Report under section 87F of the Resource Management Act 1991 on a notified resource consent application by Panuku Development Auckland Limited for consent for the construction, occupation, use and maintenance of permanent and temporary infrastructure and undertaking of activities within the coastal marine area and on land, associated with the America's Cup

From: Nicola Broadbent – Reporting Planner

Auckland Council Reference Numbers: BUN60318372

Figure 2: Proposed dredging areas and dredge depth

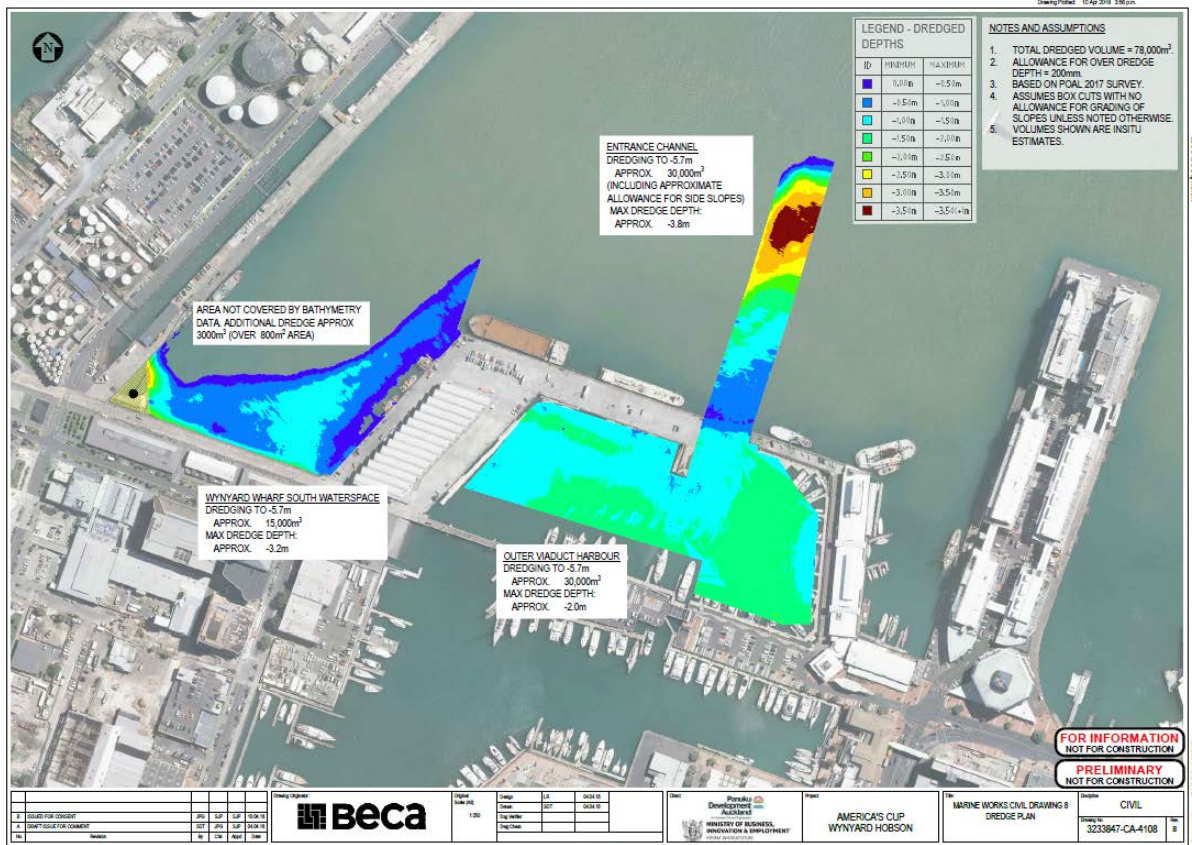
2.31 Sediment and water quality effects arise mainly from the proposed dredging and construction works. The Coastal processes and Dredging Technical Report notes (at section 5.1) that proposed dredging areas include areas/depths that have previously been dredged such as Wynyard Wharf South and approaches, as well as capital dredging in the Outer Viaduct Harbour and west of Wynyard Point. **Figure 2** provides an estimated depth of dredging based on POAL survey ~ maximum depth of 3.8m in the entrance channel (dredging to -5.7m), ~ maximum depth of 3.2m (dredging to -5.7m) in the Wynyard Basin and ~ maximum depth of 2.0m (dredging to -5.7m) in the Outer Viaduct Harbour area (refer to Document DS5.1, Engineering Concept Drawings, Civil 3233847-CA-4108; **Figure 2** below).

2.32 This information clearly indicates that dredging, at least in some areas would be up to 3.8m and has the potential to expose the anoxic layer. Whilst the sediment cores collected in Golder Report did not identify any marked differences in the redox potential discontinuities, the length of cores (1m) used in this study might not be deep enough for this site to identify the difference in the redox potential or the thickness of

Figure 3: Tidal modelling output locations for the Wynyard Wharf South Waterspace and Viaduct Harbour (reproduced from Coastal Process Report, Figure 10).

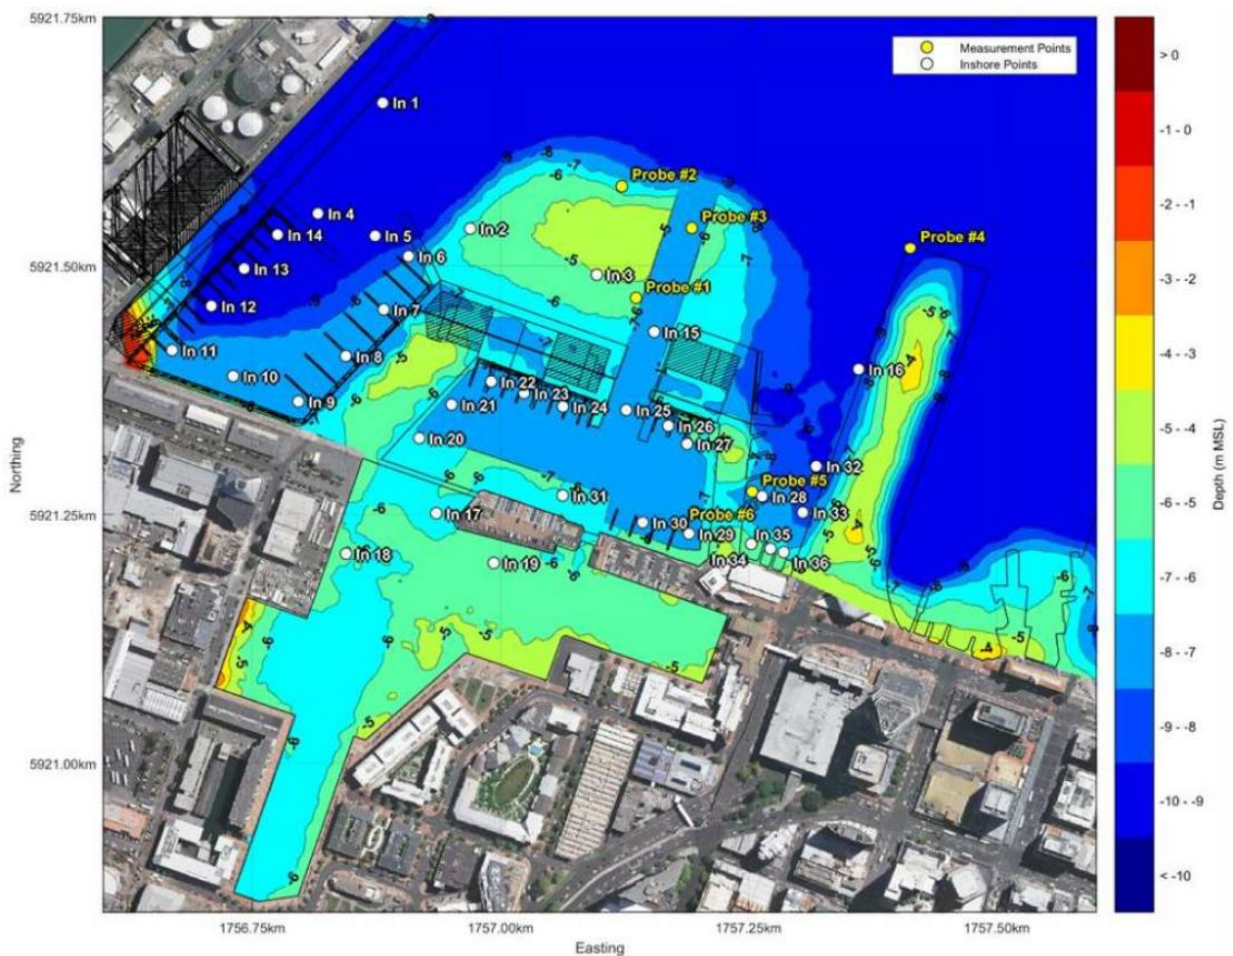
- 3.3.5 Contrary to the line of thought above, it is noted that modelling point 7 (**Figure 3, Appendix A**) shows a reduction in the average tidal velocities. This may be a result of its location at the existing entrance to the Viaduct Harbour. A reduction in velocities at this point may be a result in the seaward shift of the entrance point and a settling of the current velocities as water moves around the new structures.

- 3.3.6 An increase in the average tidal velocities is noted at modelling point 5 (**Figure 3, Appendix A**). This appears to be associated with a minor extension to the north eastern corner of Hobson Wharf. The small pier type structure will restrict existing tidal movements into the associated water body, in effect condensing the tidal currents. However, the reported increase is approximately 0.05m/s and therefore considered to be minor, with no discernible on flow effects expected.

- 3.3.7 In understanding the tidal regime, the proposed 'Wynyard Basin' area is represented by modelling points 6 and 10 (**Figure 3, Appendix A**). Predictably an increase in tidal velocities from point 6 is expected as tidal flows will be constricted around the entrance to the newly formed basin. Modelling point 10 shows reductions in the average current velocities and a maximum drop in velocities of 0.2m/s or less. Overall this is considered consistent with the creation of a basin designed to reduce the coastal processes. This in turn will potentially affect the flushing capacity of the basin and sedimentation within proposed 'Wynyard Basin'. These potential effects are discussed in more detail in the sections below.

Figure 1 - Styles Group underwater ambient noise measurements (50Hz to 24kHz)

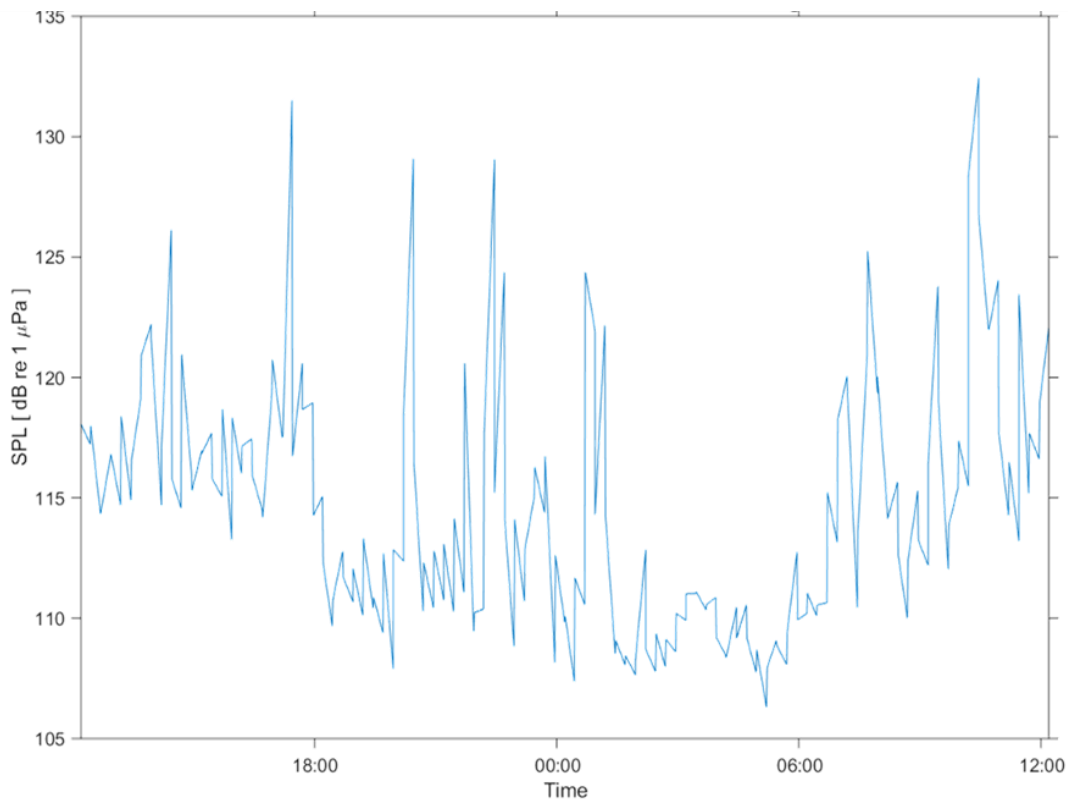
- 4.3.6 For comparison with the data presented in Figure 3 of the CNV Report, Figure 1 presents the 15 min RMS levels excluding the majority of tidal flow noise (below 50Hz). The results show levels as low as 107dB re 1 μ Pa and as high as 133 dB re 1 μ Pa. The median of the SPL data was 114 dB re 1 μ Pa and the Mode of the SPL data was 111 dB re 1 μ Pa.

- 4.3.8 However, the lowest measurement value of our measurements is approximately 7 dB re 1 μ Pa lower than that reported in the CNV Report, with considerable periods of time when the noise levels were much lower than the lowest values plotted in Figure 6 of the CNV Report for the same position. The measurement data has been overlaid onto a random day selected from Figure 6 of the CNV Report to demonstrate the difference clearly. Our measurement data depicts an environment considerably quieter than that described in the CNV Report.

4.3.9 For the reasons set out above, we consider that the ambient noise measurements presented in the CNV Report are likely to overstate the ambient underwater noise levels by a considerable margin. We have not investigated the reasons for the differences, but we note if ambient underwater noise levels do become relevant to the assessments, the data presented in the CNV Report should be treated with caution.

Figure 2 - Styles Group measurements (thin trace) overlaid on CNV Report Figure 6

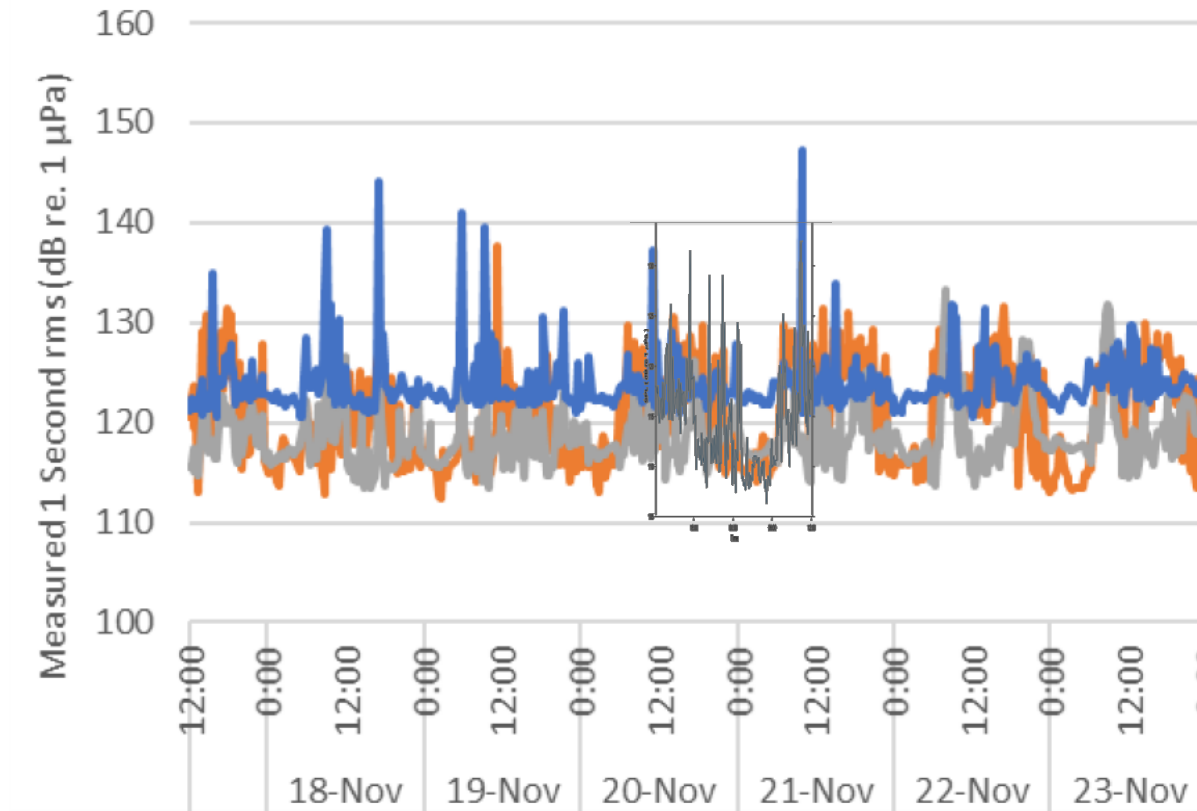
- 4.3.7 Figure 6 of the CNV Report shows that the range of measured levels at MP2 was from approximately 114 dB re 1 μ Pa to 133 dB re 1 μ Pa. The highest measurement for each set of measurements is approximately the same which is expected. This will likely be caused by a vessel passing close by.

Figure 4: Proposed Wynyard Point Bases¹³

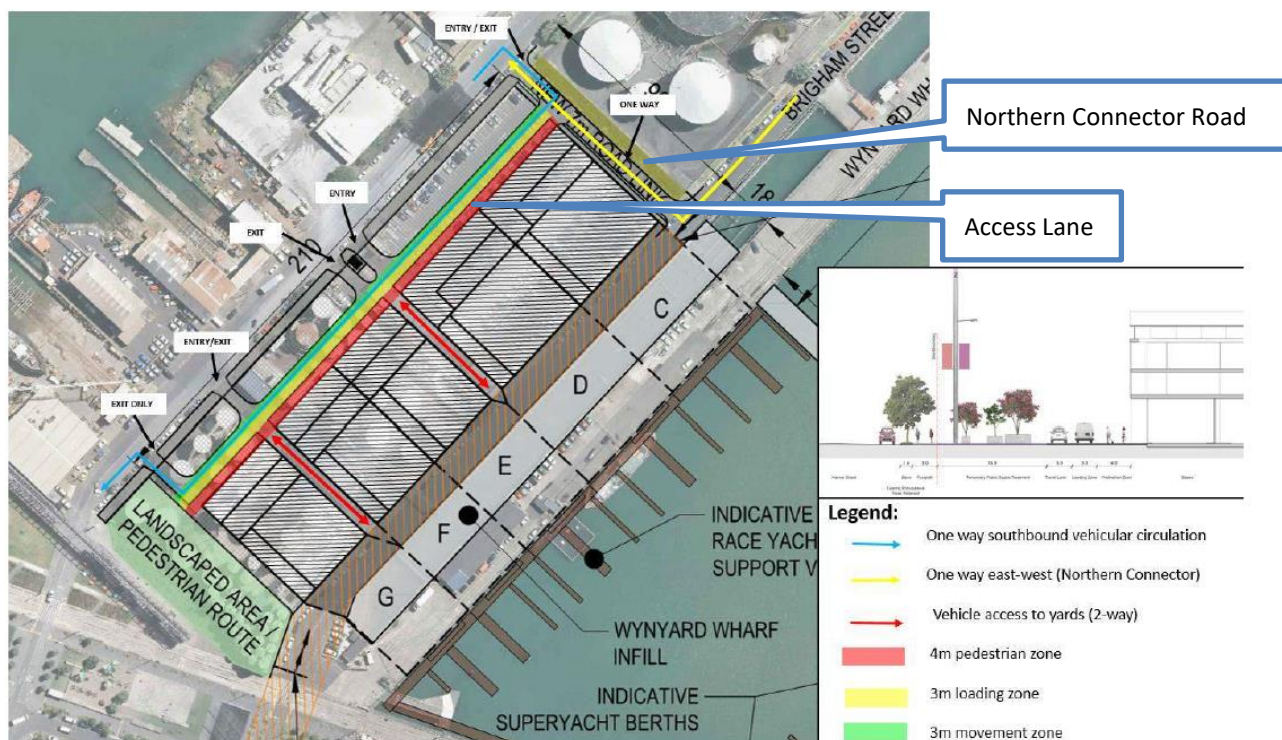
- 5.1.17 As shown previously in **Figure 4**, the transport related design aspects of the five syndicate bases include three vehicle accesses from Hamer Street (two, two-way accesses and one egress only access) and one access from the Northern Connector Road (entry only) into a new one-way southbound only lane, located to the west of the syndicate bases.

- 5.1.18 The concept design of the Hamer Street vehicle crossings to the bases as shown in **Figure 4** (including tracking assessment) has been reviewed, and while the designs are not 100% compliant with the design rules in the Transport Chapter of the Auckland Unitary Plan, Operative in Part, we consider the concept designs to be fit for purpose and can be used as a basis for the preliminary design. Notwithstanding this, we note that where the Hamer Street and Northern Connector Road footpaths intersect a new vehicle crossing to the bases, the overlapped area shall be designed and constructed to the same levels, using the same materials, kerbing, paving, patterns and finish as the footpath, on each side of the crossing.

- a. The detailed design and construction of access to the Wynyard Point bases, including the Access Lane, shall be to the satisfaction of Team Leader Compliance Monitoring Central in general accordance with Beca Drawing 3233847-CA-4201, Revision B, Wynyard Point Works Civil Drawing 1, General Arrangement Plan, and McIndoe Urban Boffa Miskell Drawing Wynyard Point Bases Public Realm Integration, Date 13 April 2018, Revision A. The design of the Access Lane shall have specific input from road safety engineers who have experience in the design of shared zones. A road safety audit shall be undertaken on the detailed design and after construction, and the reporting and decisions shall be provided to the Team Leader Compliance Monitoring Central.

Figure 5: Proposed Wynyard Point Bases: Public Realm Integration¹⁵

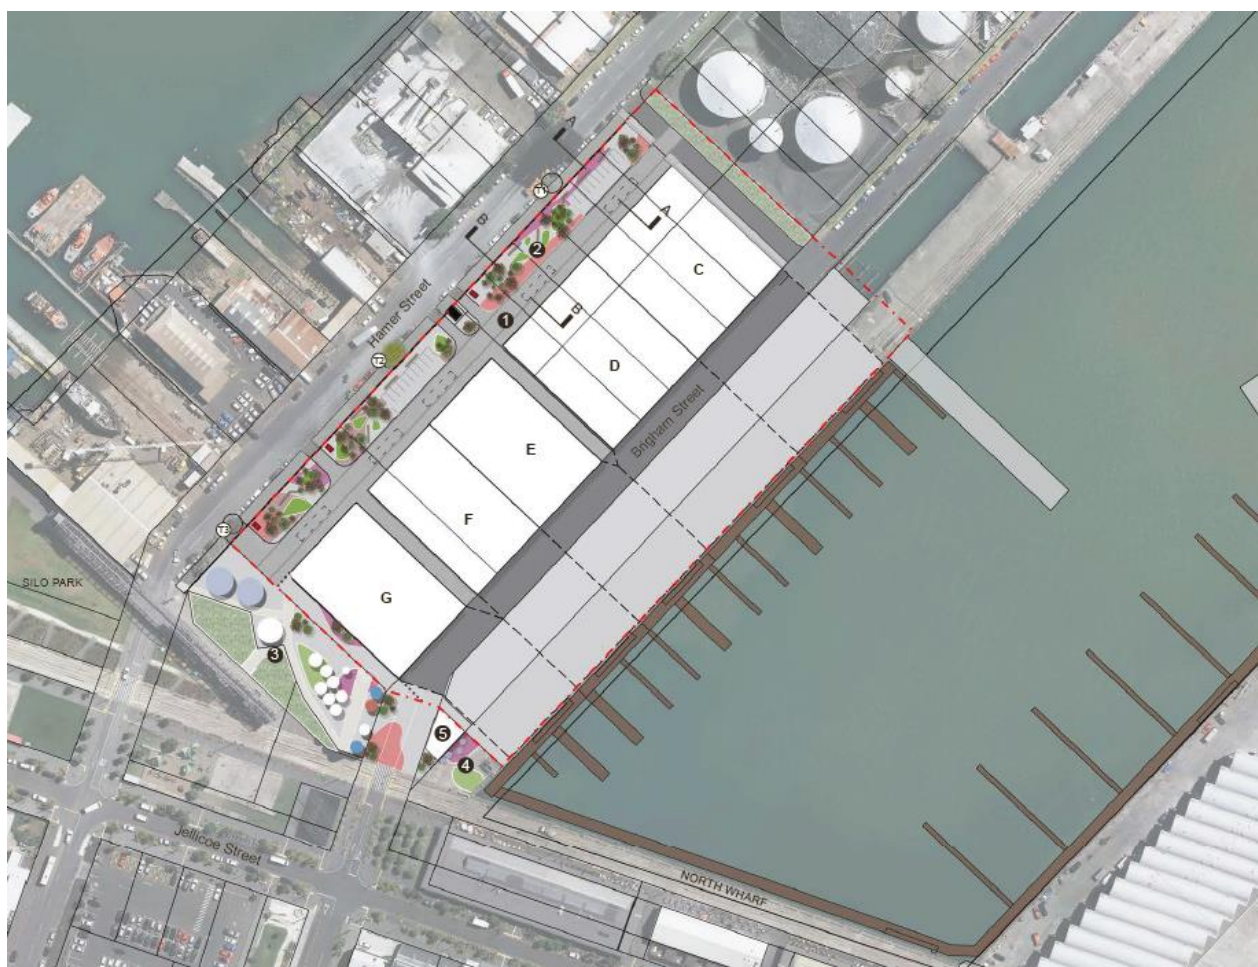
5.1.3 The proposed changes remove the potential crash risks between vehicles and pedestrians/cyclists at the existing Brigham Street crossing of North Wharf, which is positive. As shown in **Figure 5**, it appears that the proposal suggests the areas either side of the stopped

section of Brigham Creek between North Wharf and Base G will become a plaza area (items 3 and 5 in **Figure 5**), with the stopped section of Brigham Creek between Jellicoe Street and North Wharf remaining with the appearance of a road. It is understood that the only use of these stopped sections of Brigham Street will be for the managed limited exit from the bases of oversized loads and two-way emergency vehicle movements¹⁴. It is recommended that careful consideration is given to the layout and design of both of these sections of stopped road to ensure that the potential for conflicts between vehicles, pedestrians and people cycling is eliminated, and that adequate advice/delineation is given that this section of Brigham Street is closed to vehicles (other than those authorised to use it) or alternatively (ideally) the section of stopped Brigham Street between Jellicoe Street and North Wharf is also designed as a plaza.

Figure 6: Northern Collector Road Concept¹⁷

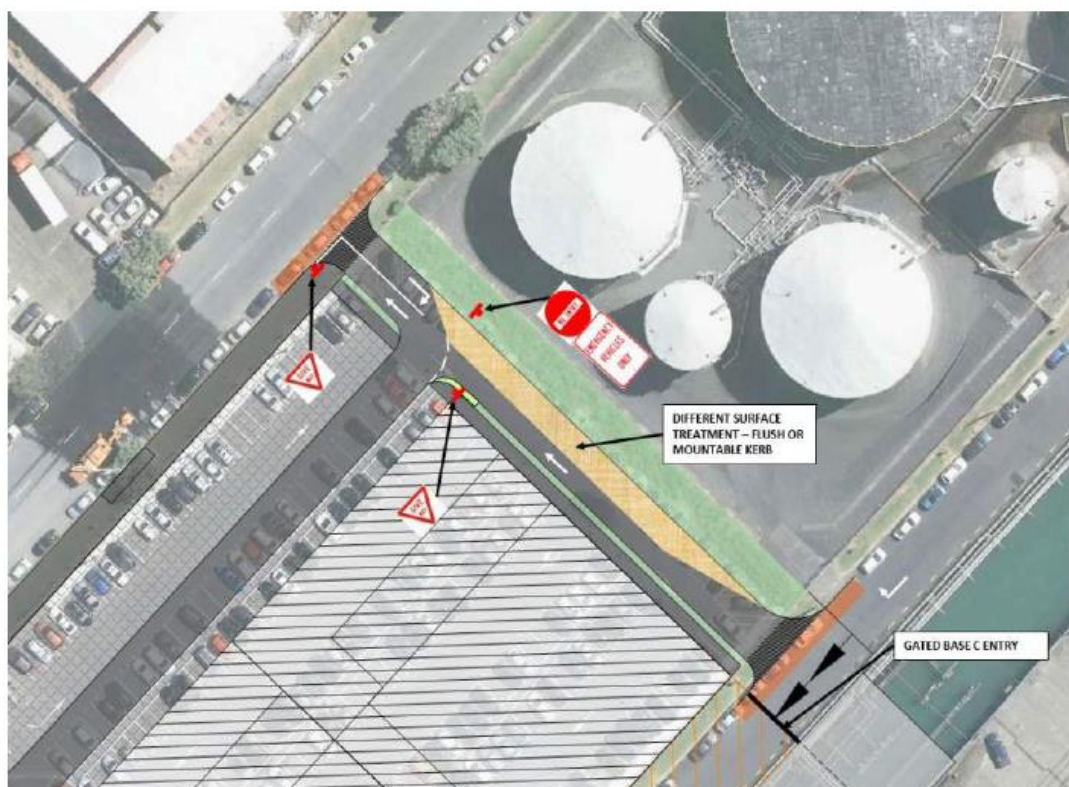
5.1.9 The resulting road network is shown in Figure 6-1 of the Beca TA report and includes altering the northern ends of Hamer Street (from north of the access to 124 Hamer Street) and Brigham Street to one-way clockwise traffic circulation, with the new Northern Connector Road linking Brigham Street to Hamer Street. This new Northern Connector Road is envisaged to be a private road with the concept design shown in **Figure 6**, allowing for a 6.0 m wide landscaping strip along the northern edge, a 7.0 m wide carriageway and a 1.0 m landscape berm and 2.0 m footpath on the southern side. It is understood that no parking will be allowed on this road and that the final design will be completed in consultation with Auckland Transport. In this regard, we note that Auckland Transport has indicated that they do not accept that the right turn movement from the Northern Connector Road into the Access Lane serving the bases should have the right of way over westbound through traffic on the Northern Connector Road, and the concept design should be accordingly altered.

5.1.10 Subject to this alteration and the provision of appropriate facilities for both pedestrians and cyclists between Daldy Street/Jellicoe Street and North Wharf/Silo Park and onward to Hamer Street and the Access Lane, we consider that the concept design is suitable to accommodate the expected transport demands and will adequately mitigate the effects of stopping the southern section of Brigham Street.

The detailed design and construction of the Northern Connector Road shall be to the satisfaction of Team Leader Compliance Monitoring Central¹⁹ in general accordance with the concept design given in Figure 4-4 of the Beca TA report, with changes to the design including that the right turn movement from the Northern Connector Road into the Access Lane serving the bases has to give way to

Figure 7: Proposed Cross Section of the Access Lane and Location of New Footpath on Hamer Street²²

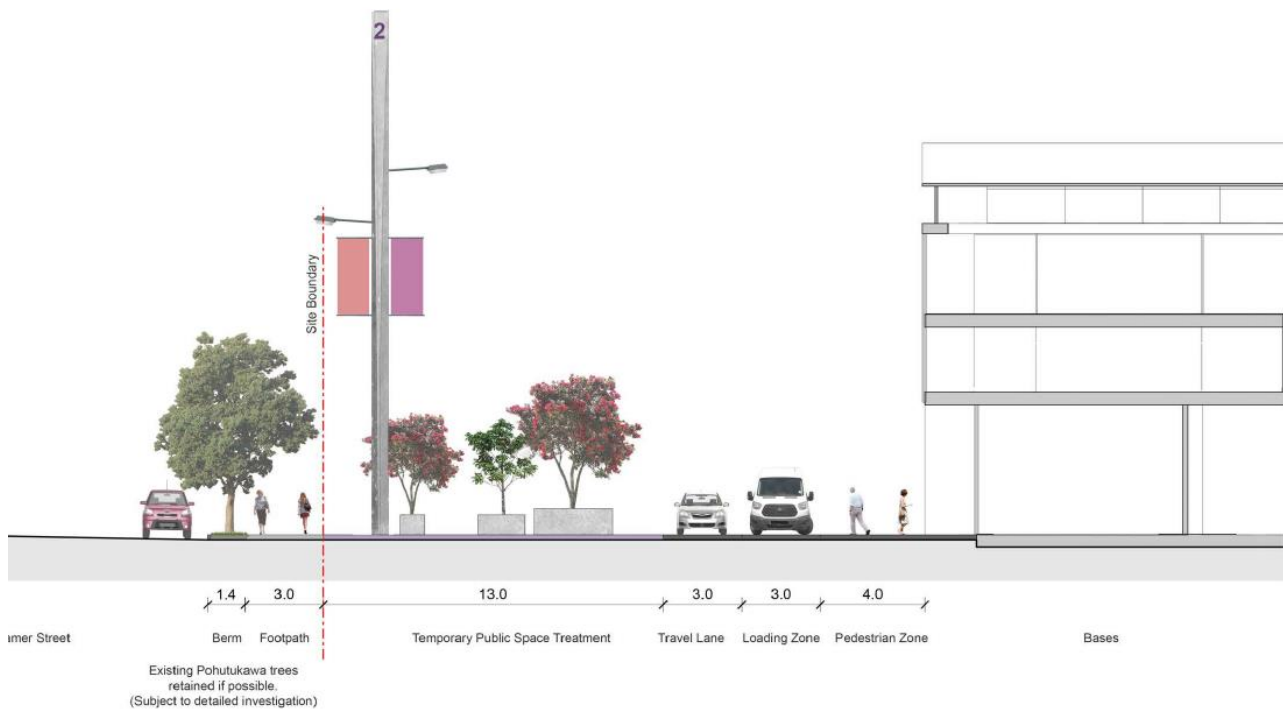
- 5.1.14 The typical cross section of the Access Lane is shown in **Figure 7** and while a 4.0 m wide pedestrian zone adjacent to the bases, a 3.0 m wide loading zone, and 3.0 m wide southbound only vehicle lane is shown, it is understood that this area is intended to operate as a shared zone with low vehicle speeds. The Beca TA report notes that a key design objective for the Access Lane will be to provide for the safety of all users with particular regard to pedestrians and cyclists²¹. We recommend that the design of the Access Lane has specific input from road safety engineers who have experience in the design of shared zones, particularly as the Access Lane provides for southbound vehicle movements only, but pedestrians and cyclists may want to travel in both directions and means to ensure the safety of cyclists specifically, could be difficult. Road safety audits should also be undertaken.
